**Addendum No. 1**  
**March 6, 2025**

Project: Brandon Valley Middle School Addition  
Brandon, South Dakota  
Project #3090

Architect: Architecture Incorporated

**9.21**

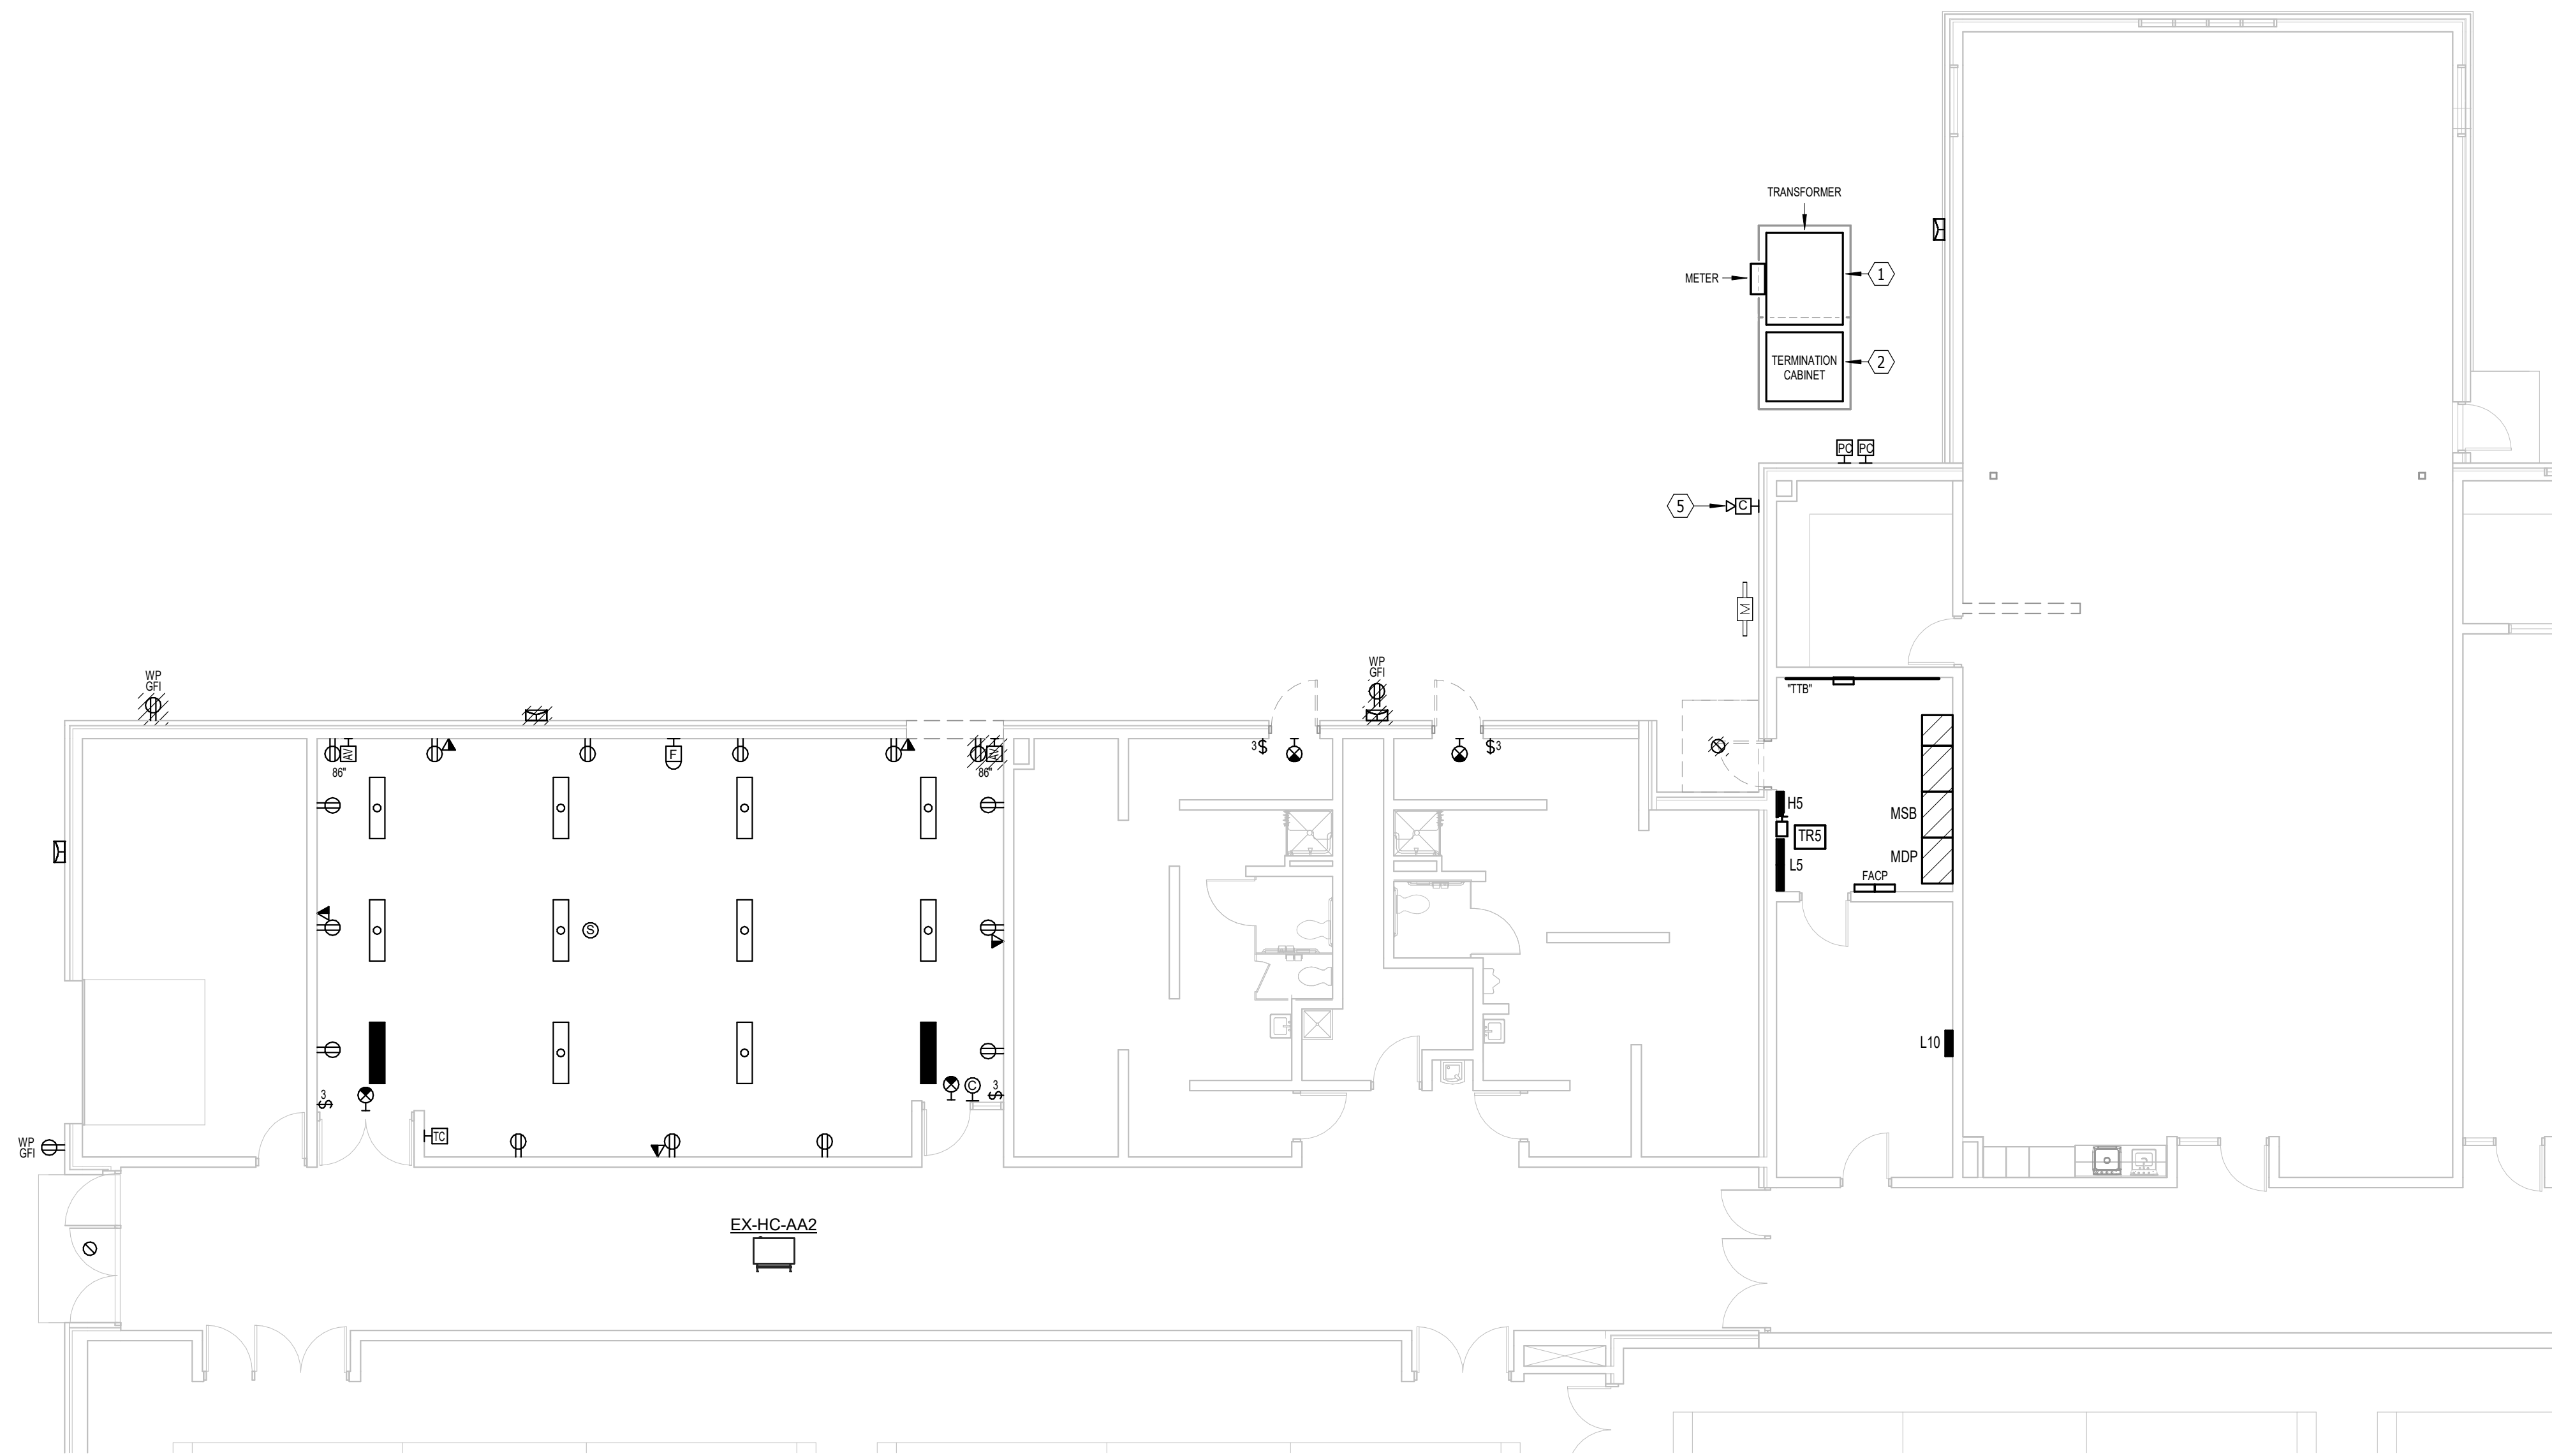
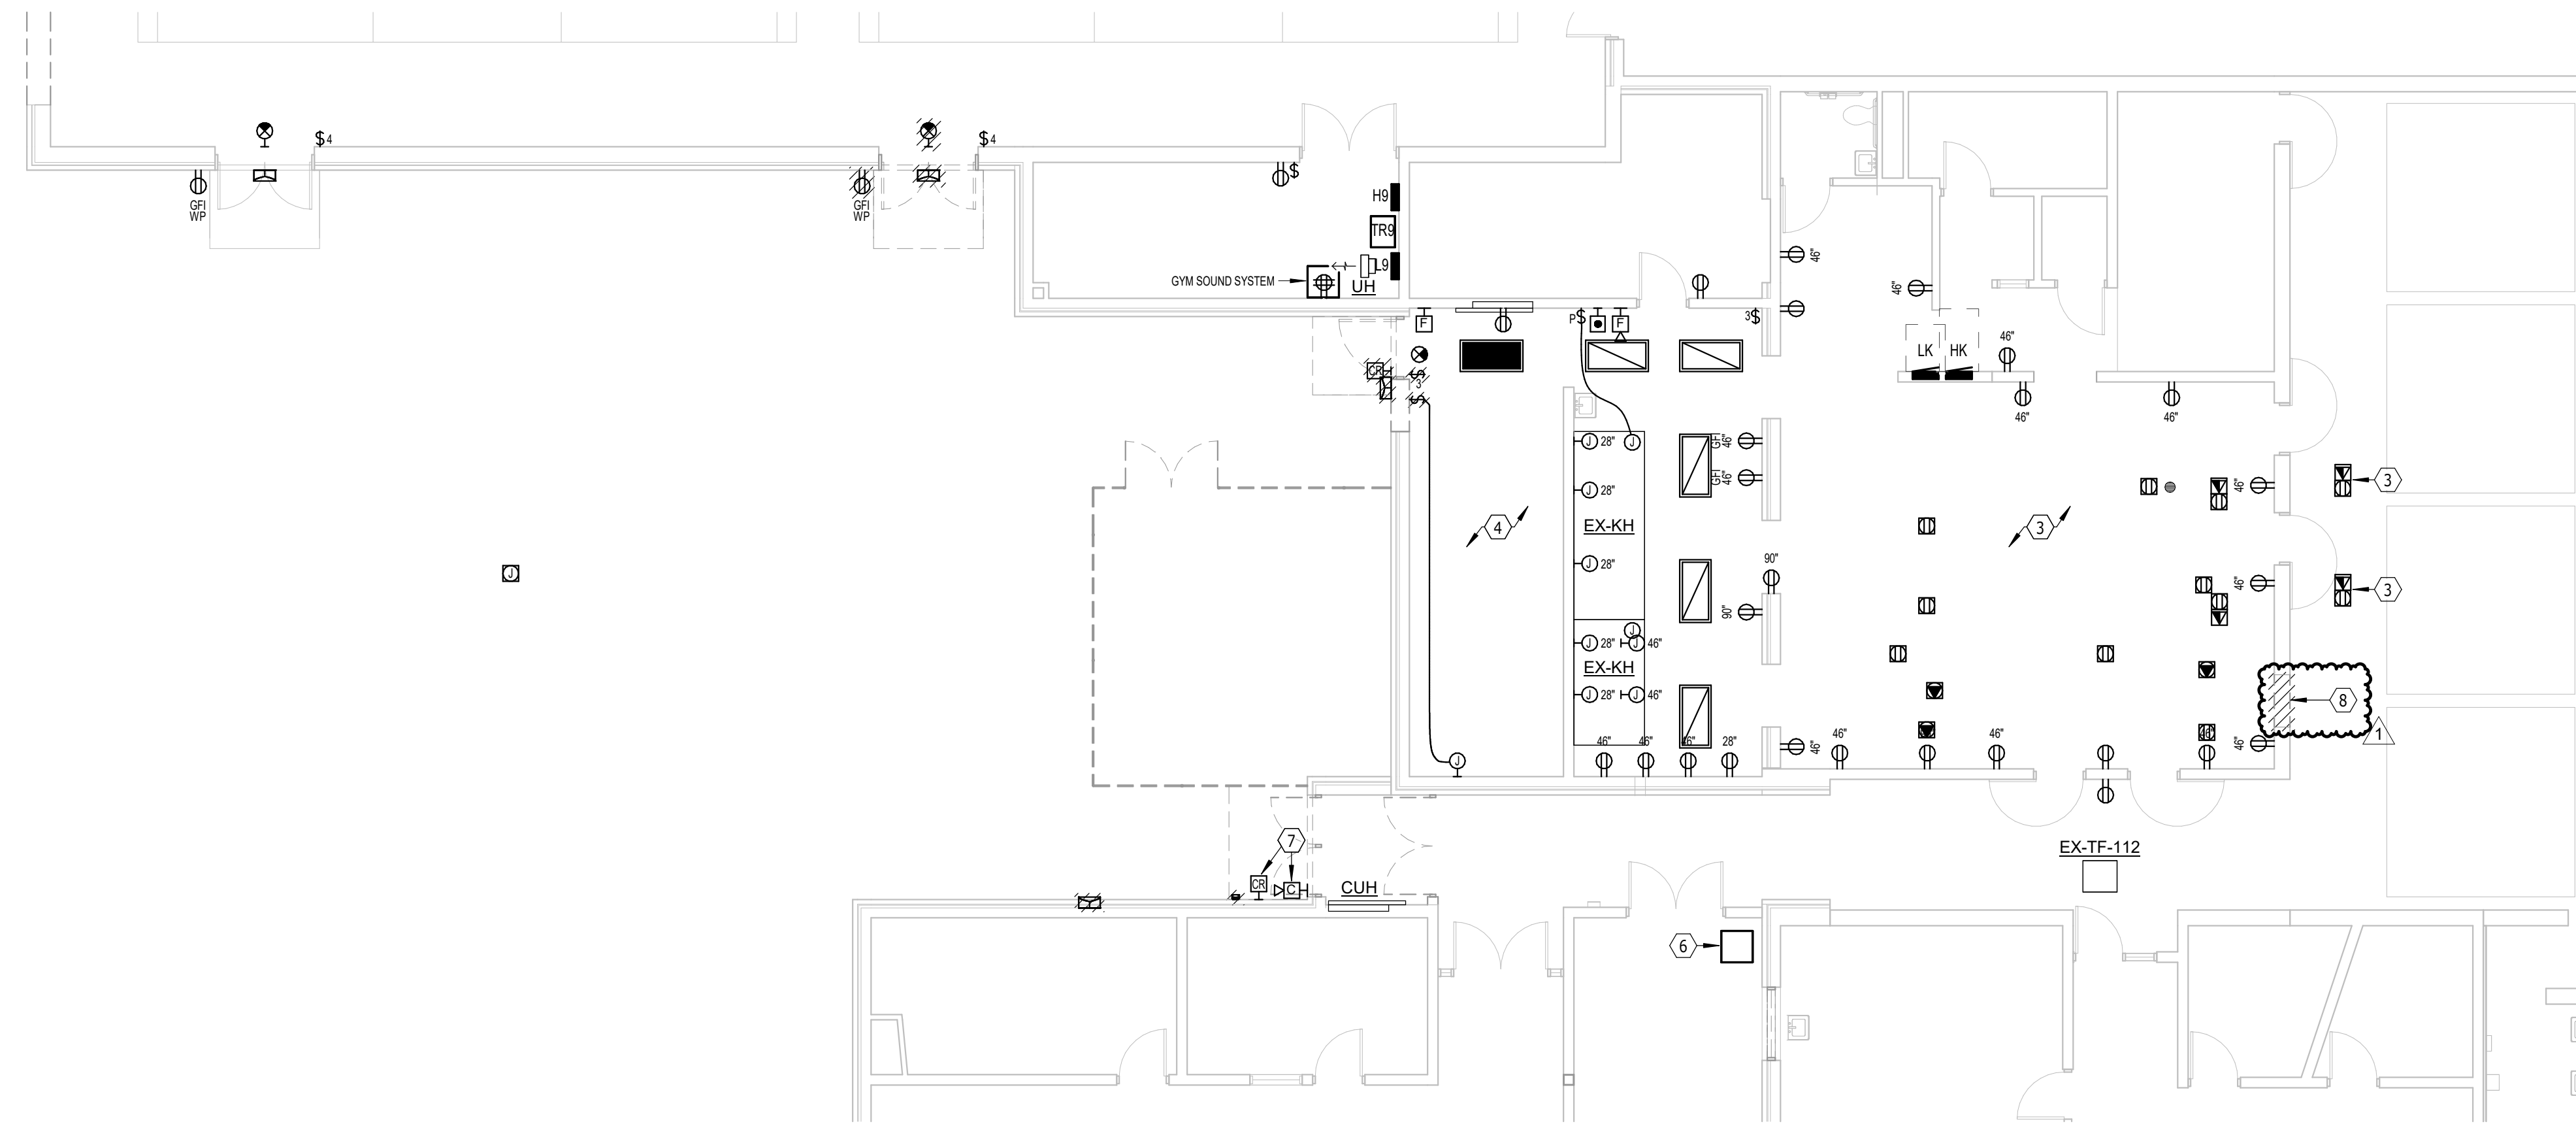
- 4) SHEET 9.21 – FIRST FLOOR DEMOLITION PLAN – AREA A1 & A2 ELECTRICAL
  - a) Add Electrical Note #8 that reads “DEMO EXISTING ELECTRICAL DEVICES IN THIS LOCATION AS REQUIRED TO ALLOW FOR INSTALLATION OF NEW DOOR.”.

- b) Reference *revised* electrical drawing drawing Sheet 9.21, revision dated 3-6-2025 attached to the end of this addendum for additional details associated with demo near the Servedy.

**9.30**

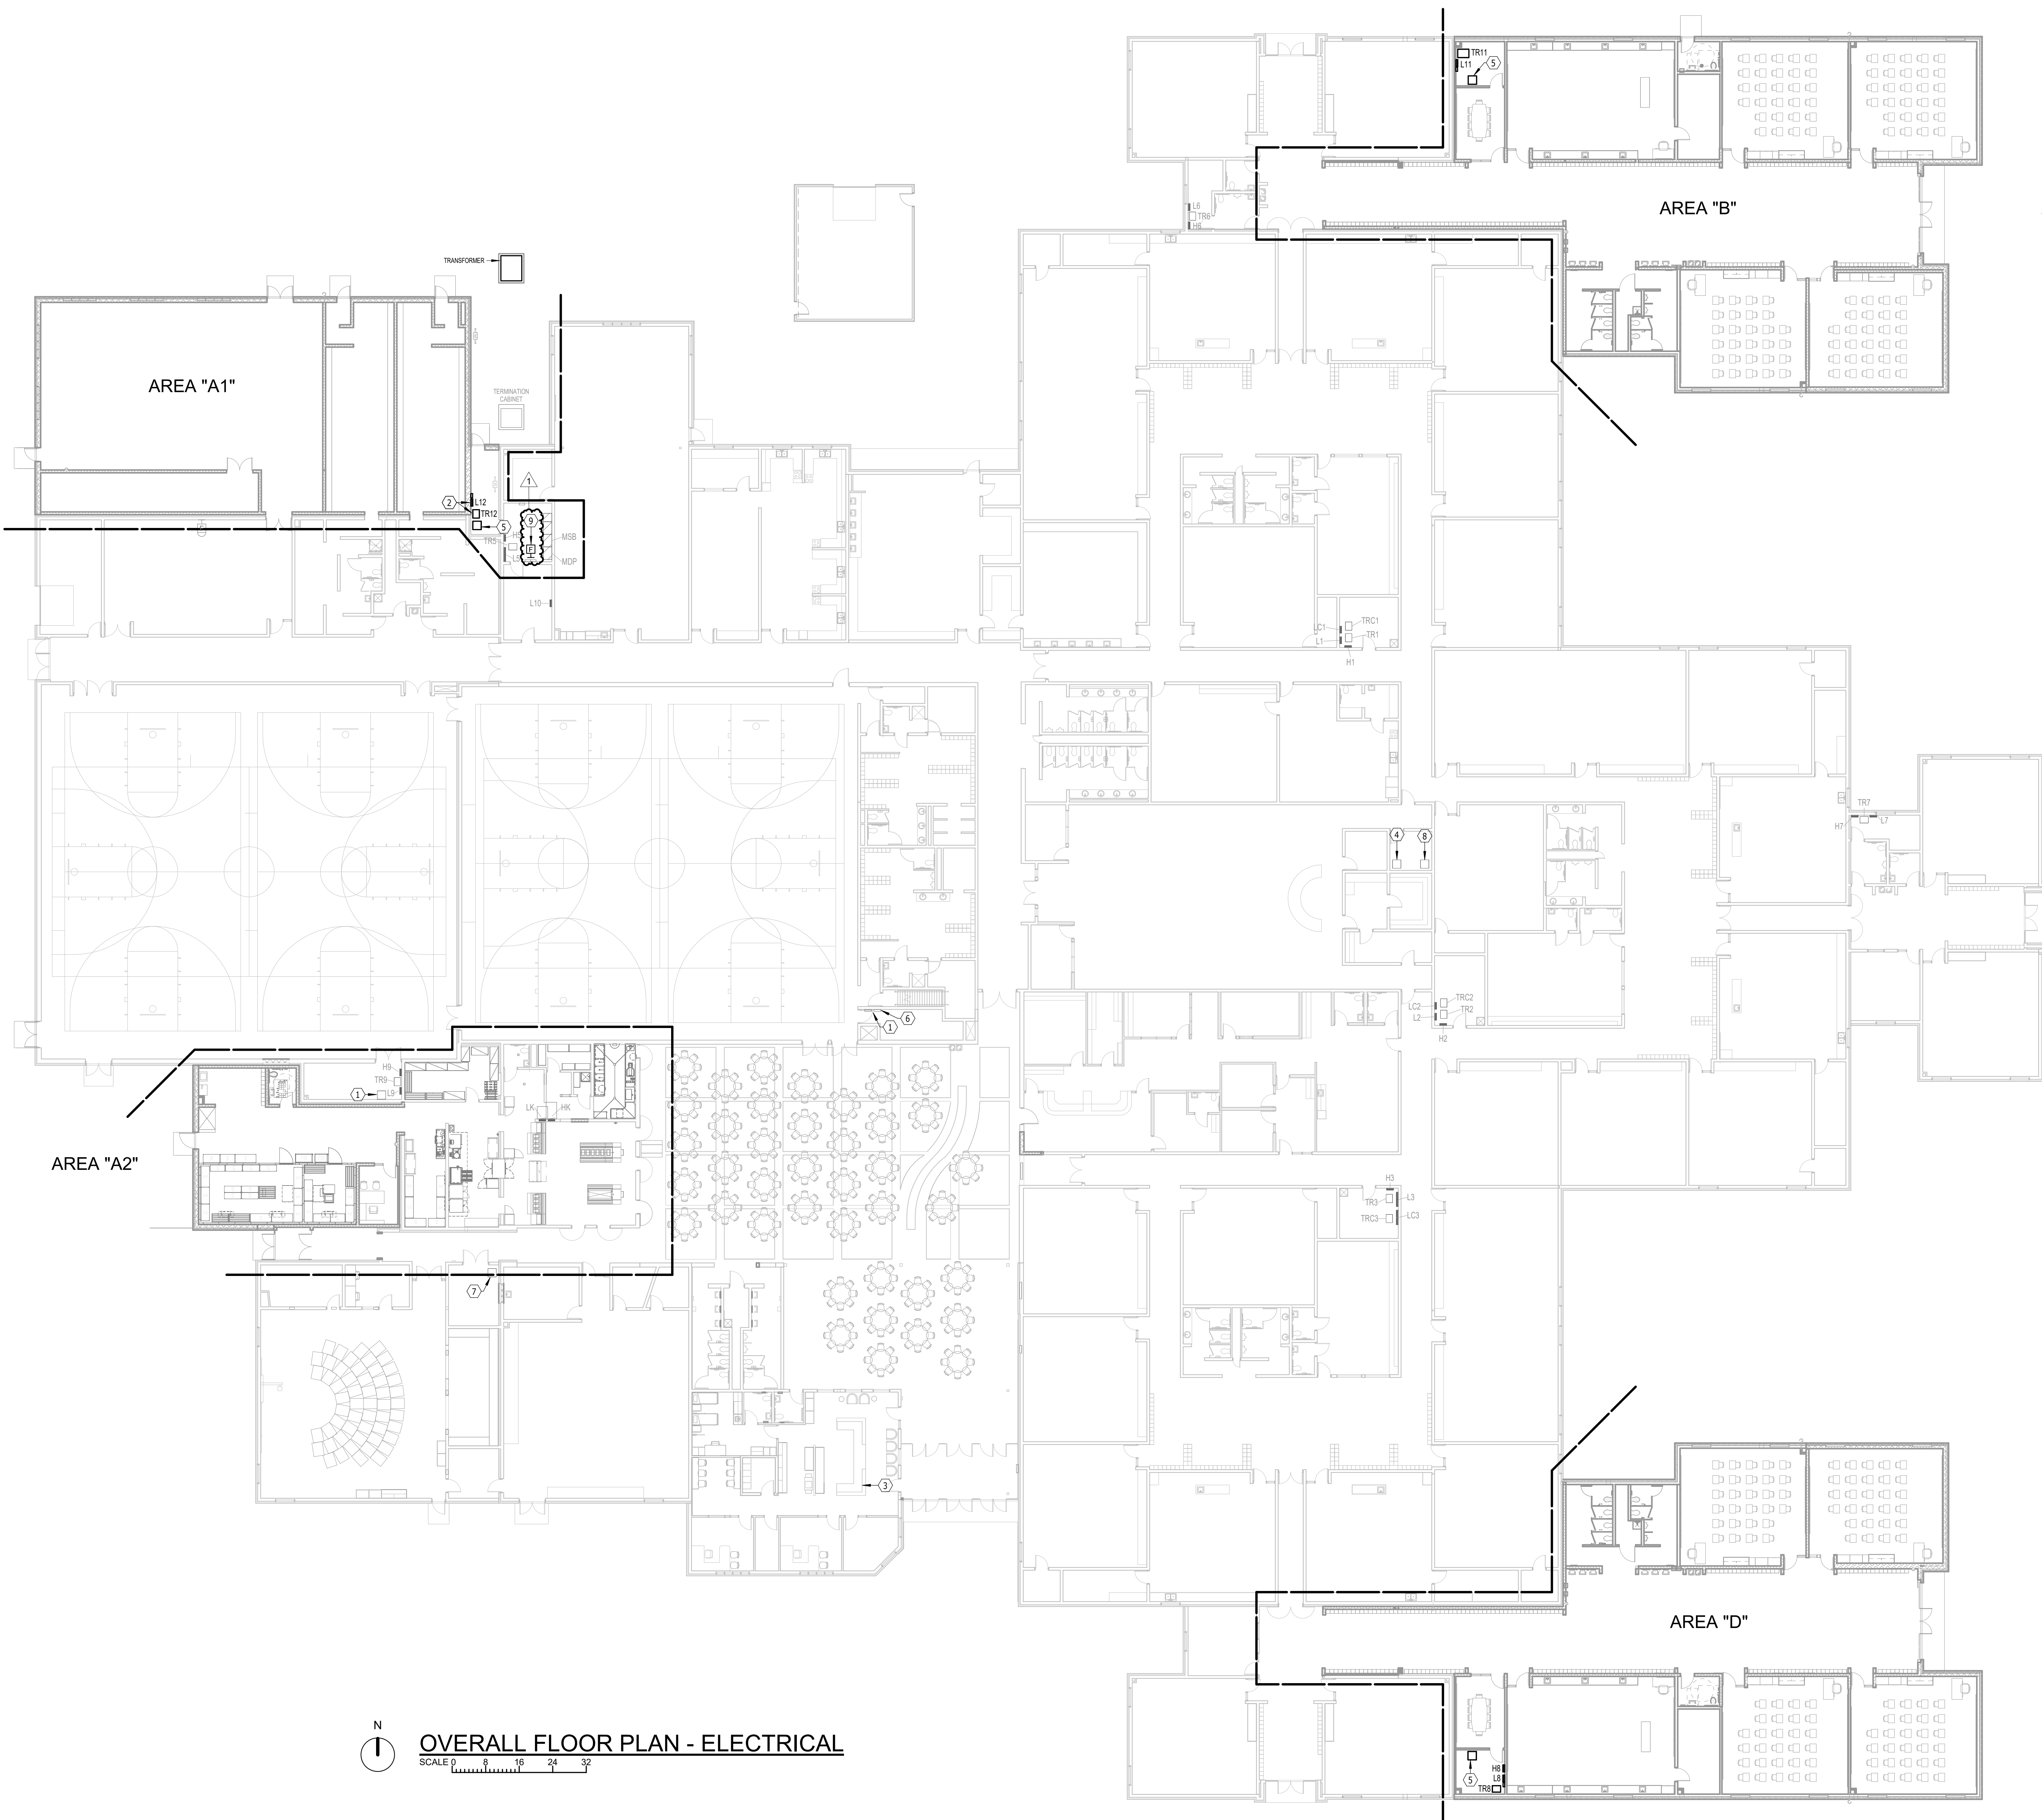
- 5) SHEET 9.30 – OVERALL FLOOR PLAN – ELECTRICAL
- a) Reference *revised* electrical drawing Sheet 9.30, revision dated 3-6-2025, attached to the end of this addendum for following modifications:
- i) Modify electrical note #3 to include qty (2) admin telephones.
- ii) Add Electrical Note #9 that reads “PROVIDE A FIRE ALARM MANUAL PULL STATION AT FIRE ALARM CONTROL PANEL LOCATION.”.
- 6) SHEET 9.40 – ENLARGED FLOOR PLANS – ELECTRICAL
- a) Reference *revised* electrical drawing Sheet 9.40, revision dated 3-6-2025 attached to the end of this addendum for miscellaneous modifications.
- 7) SHEET 9.52 – ELECTRICAL SCHEDULES
- a) Reference *revised* electrical drawing Sheet 9.52, revision dated 3-6-2025 attached to the end of this addendum for miscellaneous panelboard schedule modifications.
